UNITED STATES PATENT AND TRADEMARK OFFICE

10/564,226

| Office Action Summary | Application No. 10/564,226 | Applicant(s) THOEMMES, FRANZ | |

DETAILED ACTION

Examines Marked up Figure 9

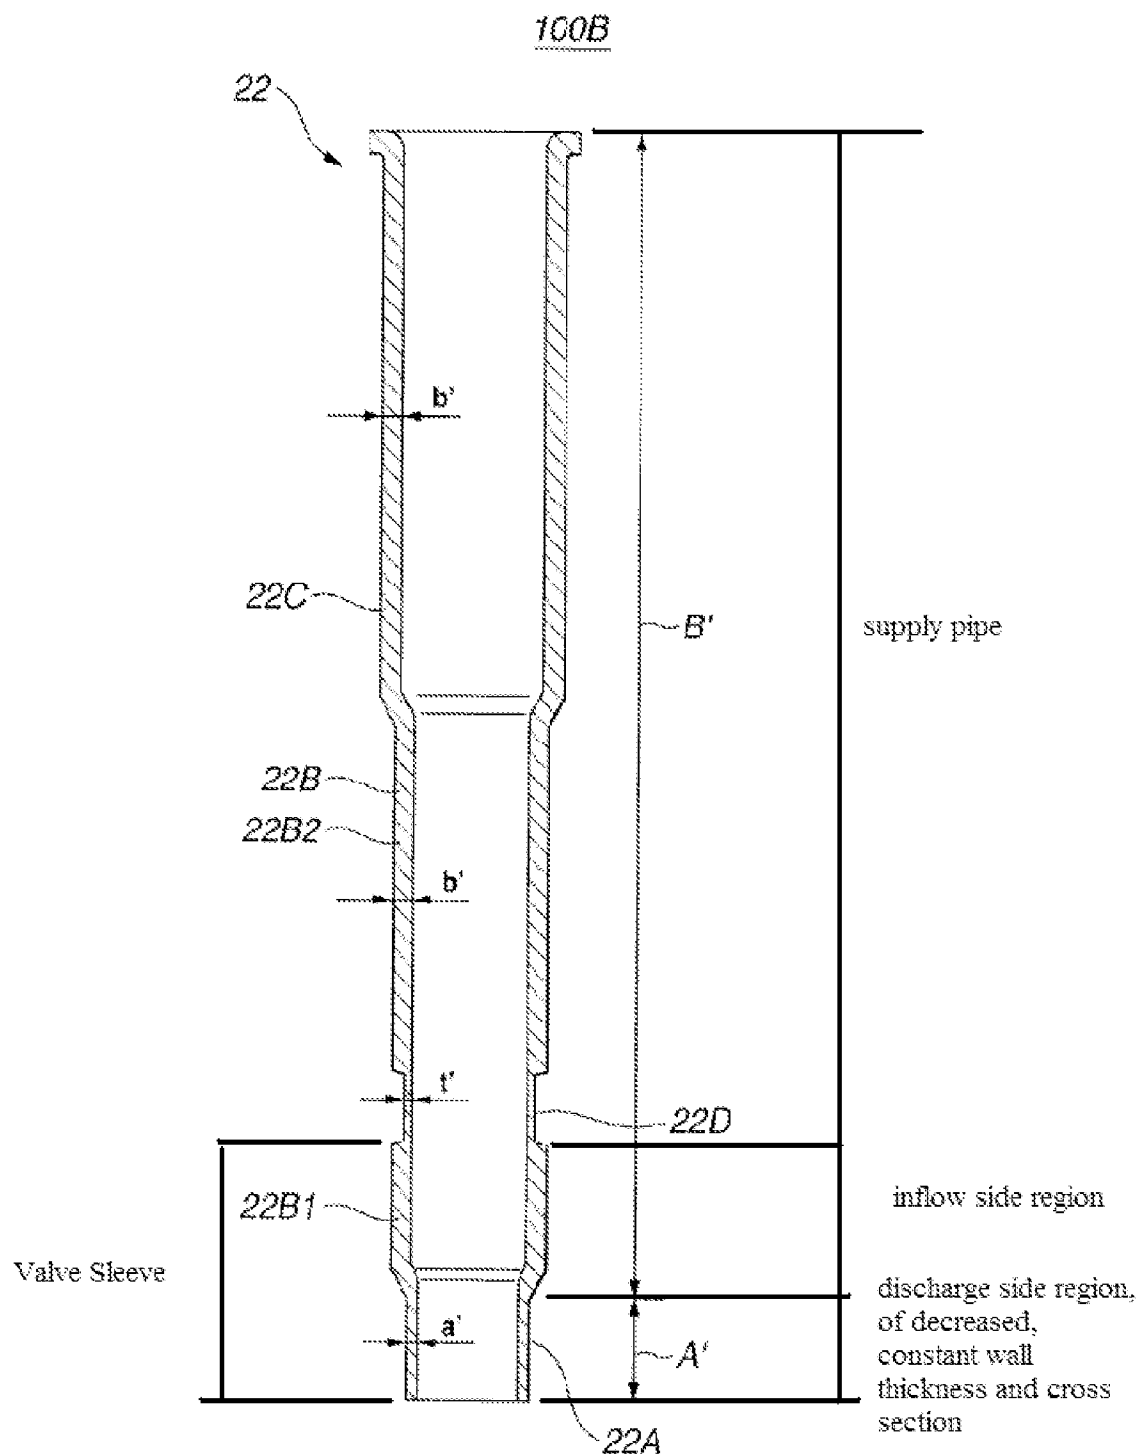
Kobayashi et al. shows a fuel injector (1) comprising; a valve needle (7a) an armature (7c) forming an axially movable valve port together with the valve needle, a restoring spring (9) acting upon the armature, a magnetic coil (11) cooperating with the armature, a valve-seat body (5b), a valve closure member (7b) which forms a sealing seat with the valve seat body and; a valve sleeve (22B1, 22A) surrounding the armature and the valve needle, a wall thickness of the valve sleeve varying across its axial

direction (fig 9), wherein the wall the wall thickness of the valve sleeve decreases in a discharge direction of a fuel (figure 9), wherein a radial cross section of the valve sleeve decreases between an inflow-side region and a discharge-side region on a color (figure 9), wherein the radial cross section and the wall thickness of the inflow-side region are constant from the collar to an inflow-side end of the valve sleeve (figure 9); wherein the decreased radial cross section and decreased wall thickness of the discharge-side region are constant form the collar to a discharge-side end of the valve sleeve (see examiners marked up figure of figure 9), and wherein the inflow side region of the valve sleeve is formed in one piece with a supply pipe (see examiners marked up figure 9).

Regarding the applicant's remarks towards the rejection of claim 8, it is noted that the location of the “inflow-side of the valve sleeve,” is not specifically claimed, the examiner is considering the inflow-side end of the valve sleeve to be everything below the indent 22D to the lower collar shown in the marked up figure 9 shown above. Therefore, the valve sleeve has a constant wall thickness and cross-sectional area from the collar to the discharge-side end of the valve sleeve, and the collar to the inflow-side end of the valve sleeve.
